CITY OF CODY  
PLANNING, ZONING AND ADJUSTMENT BOARD  
TUESDAY, JUNE 26, 2012  
CITY HALL COUNCIL CHAMBERS @ 12:00 NOON

**CITY OF CODY  
PLANNING, ZONING AND ADJUSTMENT BOARD  
STAFF REPORT**

<b>MEETING DATE:</b>	JUNE 26, 2012	<b>TYPE OF ACTION NEEDED</b>	
<b>AGENDA ITEM:</b>		P&Z BOARD APPROVAL:	X
<b>SUBJECT:</b>	SPECIAL EXEMPTION PUBLIC HEARING: REDUCE FRONT SETBACK REQUIREMENT FOR 713 MEADOW LANE AVENUE SUP 2012-05	RECOMMENDATION TO COUNCIL:	
<b>PREPARED BY:</b>	TODD STOWELL, CITY PLANNER	DISCUSSION ONLY:

<b>MEETING DATE:</b>	JUNE 26, 2012	<b>TYPE OF ACTION NEEDED</b>	
<b>AGENDA ITEM:</b>		P&Z BOARD APPROVAL:	X
<b>SUBJECT:</b>	SPECIAL EXEMPTION PUBLIC HEARING: REDUCE REAR SETBACK REQUIREMENT FOR 1237 WILLOW LANE SUP 2012-06	RECOMMENDATION TO COUNCIL:	
<b>PREPARED BY:</b>	TODD STOWELL, CITY PLANNER	DISCUSSION ONLY:

713  
MEADOW  
LANE

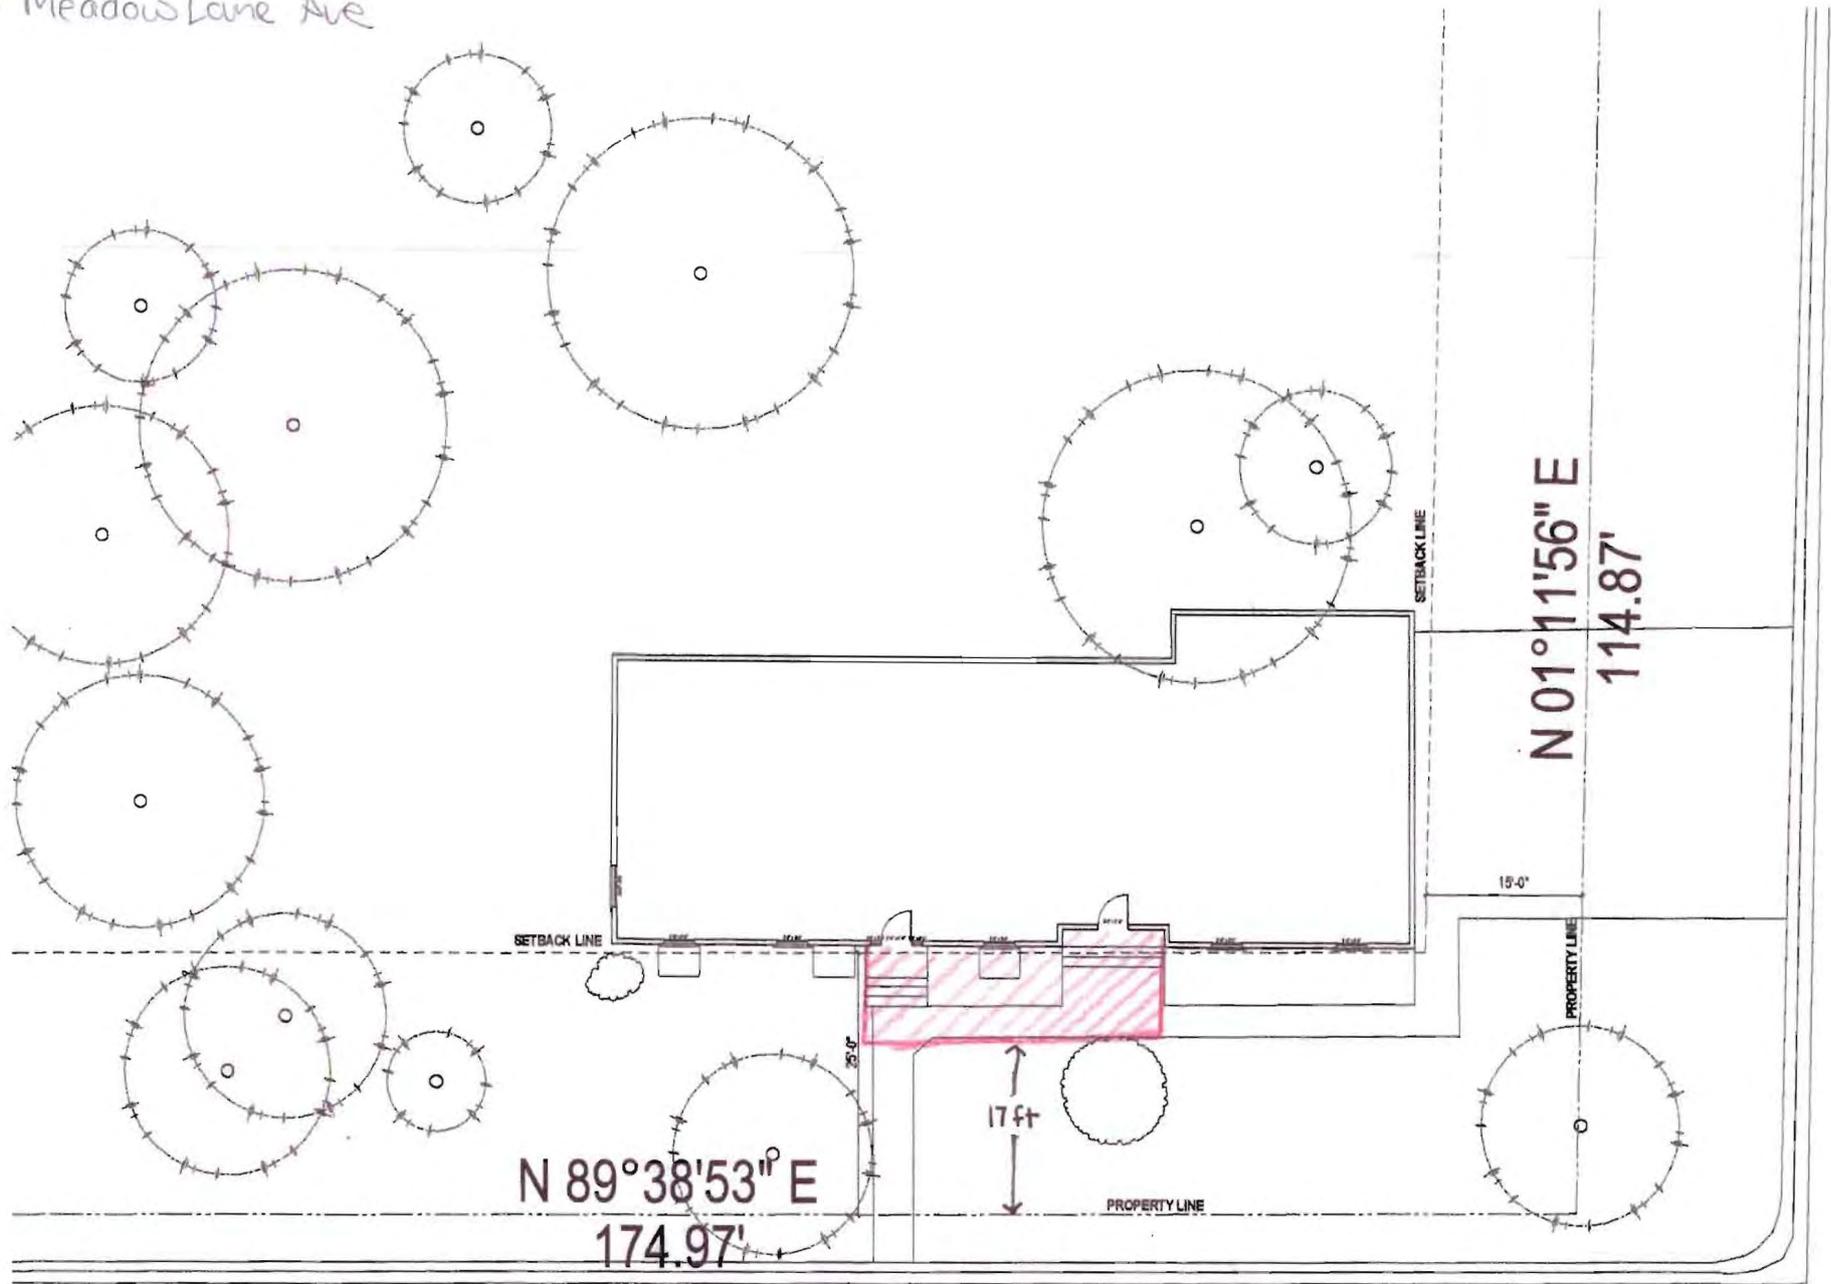
Staff Comment: Ten neighboring property owners were notified of the proposal and **all ten owners returned responses of "No Objection"**. This is interpreted as evidence that there is no undesirable change or detriment to neighboring properties from this proposal.

**Staff Comment:** Similar to question 'a' above, granting the special exemption request is not expected to create any significant compatibility issues. The addition is intended to improve the architectural appearance and functionality of the residence.

Staff Comment: The full design of the addition had not been determined at the time this application was submitted. It may be that the addition will extend slightly less than eight feet from the existing house. In order for the porch to be functional, rather than just decorative, it would seem reasonable that a six to eight foot width would be needed. **The Board can discuss whether the waiver is the "minimum necessary" if they have concerns.**

Staff Comment: No services are proposed or needed for the porch addition. There do not appear to be any utility mainline conflicts with the proposed location, although service lines may need to be accommodated. Utility locates will need to be conducted.

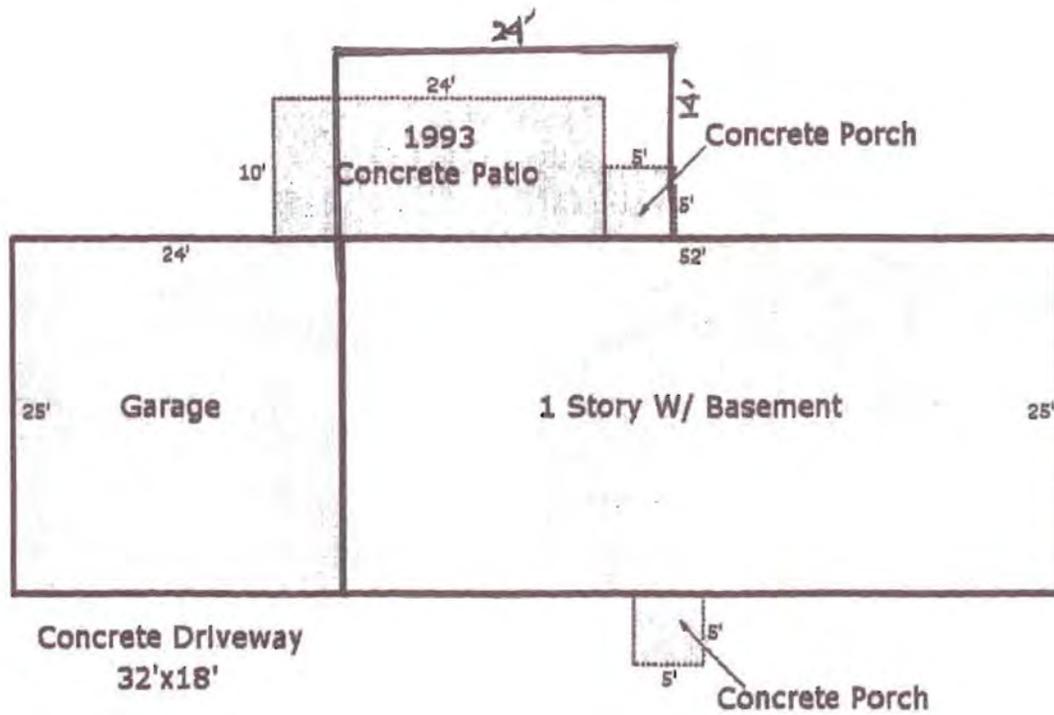
Staff Comment: Ten neighboring property owners were notified of the proposal and seven **owners returned responses of "No Objection"**. Three neighbors did not respond. The four closest neighbors to the north, which would be the most affected **by any activity on the north side of the Okada home, responded with "No objection"**. The responses are interpreted as evidence that there is no undesirable change or detriment to neighboring properties from this proposal.

Staff Comment: The proposed addition is fourteen feet wide, which is a standard room width in modern construction. The triangular shape of the lot results in a **portion of the addition not meeting the 15' setback requirement**. The Board can **discuss whether the waiver is the "minimum necessary" if they have concerns**.

Staff Comment: No new services are proposed or needed for the addition. There do not appear to be any utility mainline conflicts with the proposed location, although service lines may need to be accommodated. Utility locates will need to be conducted.

C1

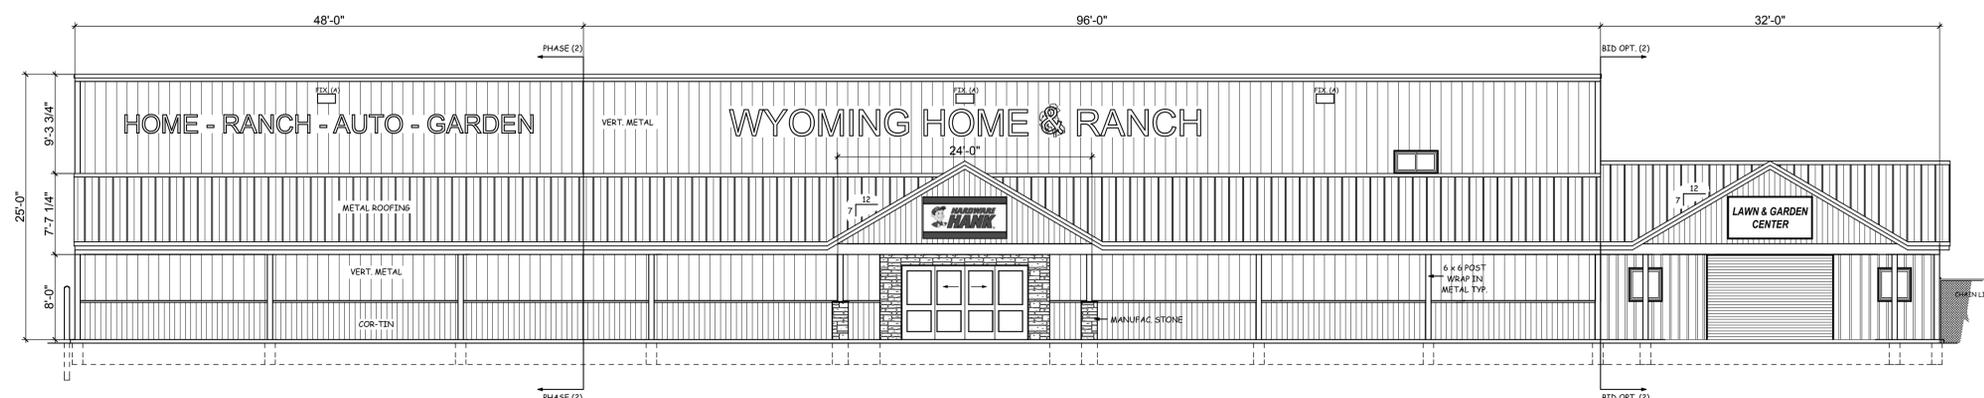
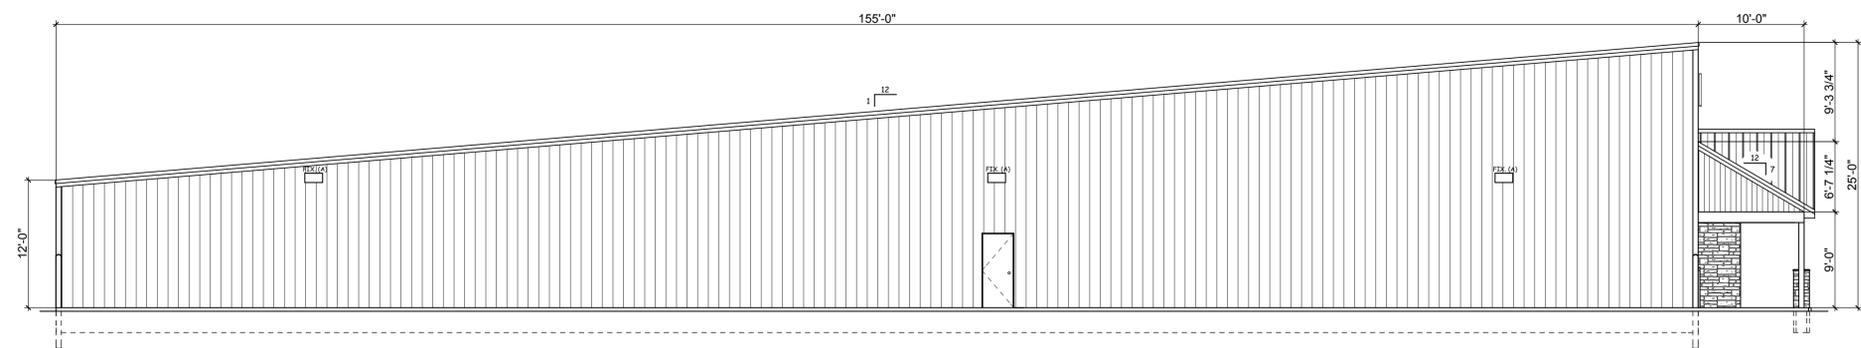
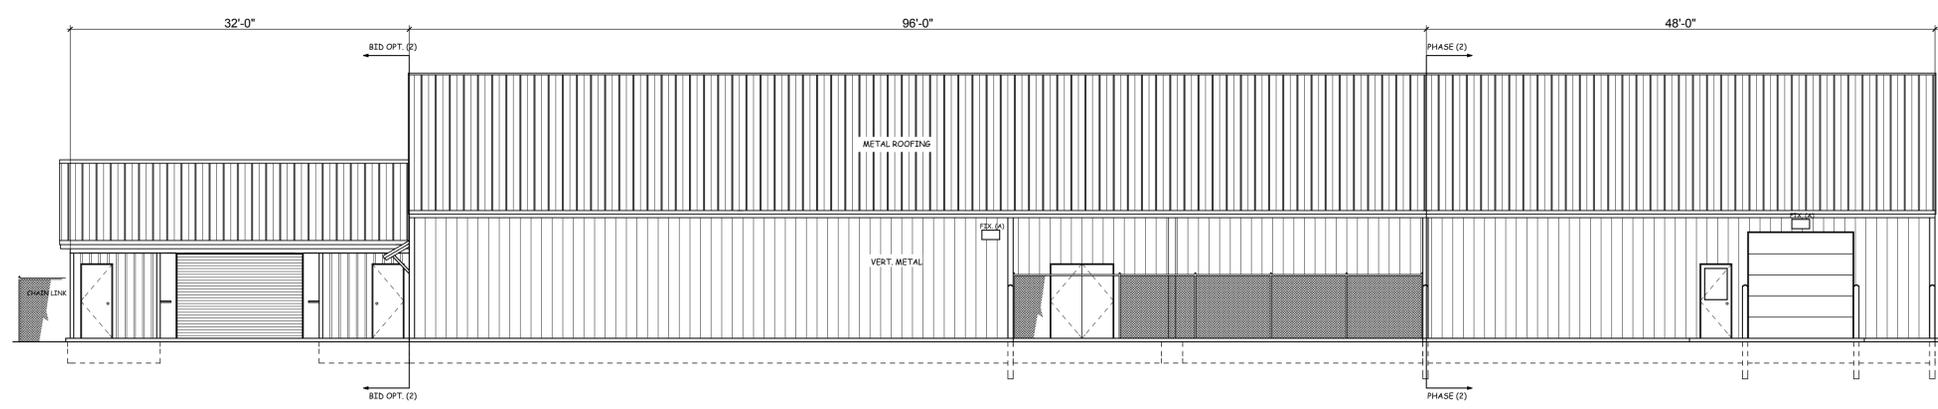
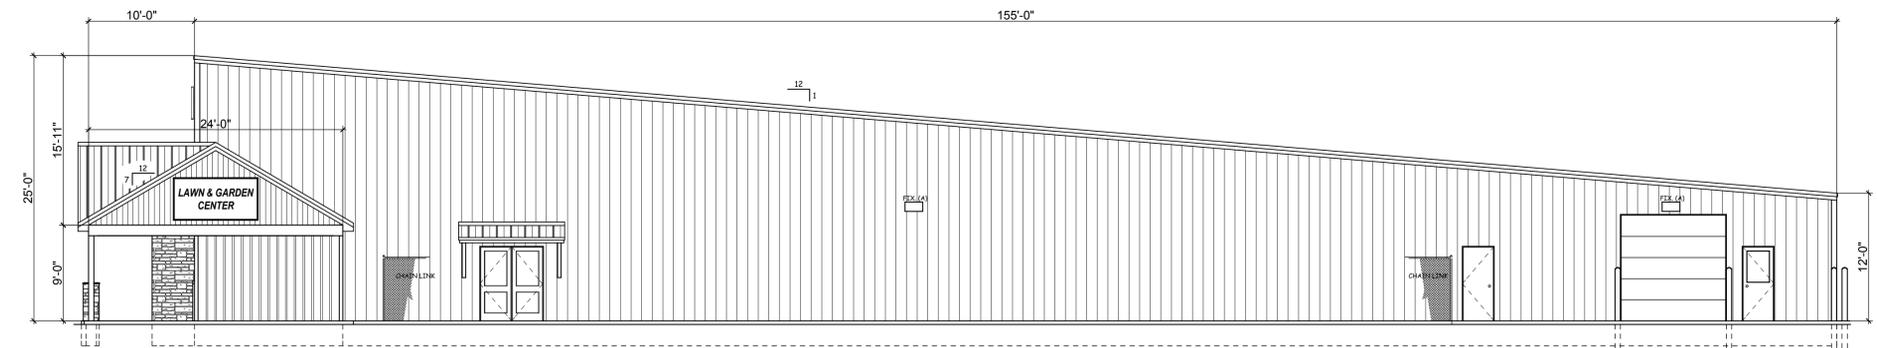
17. Sheet C1 refers to gutters, yet we did not see any on the plans. At a minimum you may want gutters above the loading door in Phase II. If the official sidewalk is outside of the covered awning area you may want to consider gutters and/or snow retention stops to prevent water/snow/ice from falling onto the sidewalk.
